APPLICATION NO.	FILING DATE	FIRST NAMED INVENTOR	ATTORNEY DOCKET NO.	CONFIRMATION NO.
10/527,743	03/14/2005	Yasushi Maruyama	SON-2814	9126
23353 7590 11/13/2007 RADER FISHMAN & GRAUER PLLC LION BUILDING 1233 20TH STREET N.W., SUITE 501 WASHINGTON, DC 20036			EXAMINER KEBEDE, BROOK	
			ART UNIT 2823	PAPER NUMBER
			MAIL DATE 11/13/2007	DELIVERY MODE PAPER

Office Action Summary	Application No. 10/527,743	Applicant(s) MARUYAMA, YASUSHI	
	Examiner Brook Kebede	Art Unit 2823

DETAILED ACTION

FIG. 1A

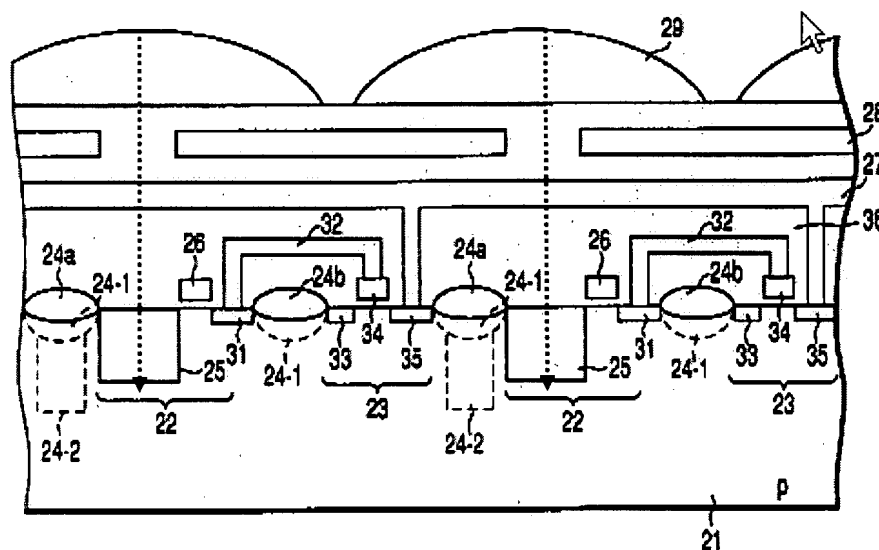
It is respectfully submitted that the claimed limitations that applicant contend that Inoue et al. do not teach is within inherent future of Inoue et al. discloser.

As depicted in Fig.1 above, Inoue et al. clearly show the microlens positioned to central part of photodiode. Inoue et al. also clearly disclose that the *focusing lens 29 is a microlens formed in each cell to form an optical image on the photodiode 25 of the cell*. In other word, the focal point of the lens 29 is directed toward the center of the photodiode 25. Further, The

drawings, as shown in Figs. 1-3 clearly teach the claimed subject matter of the instant application.
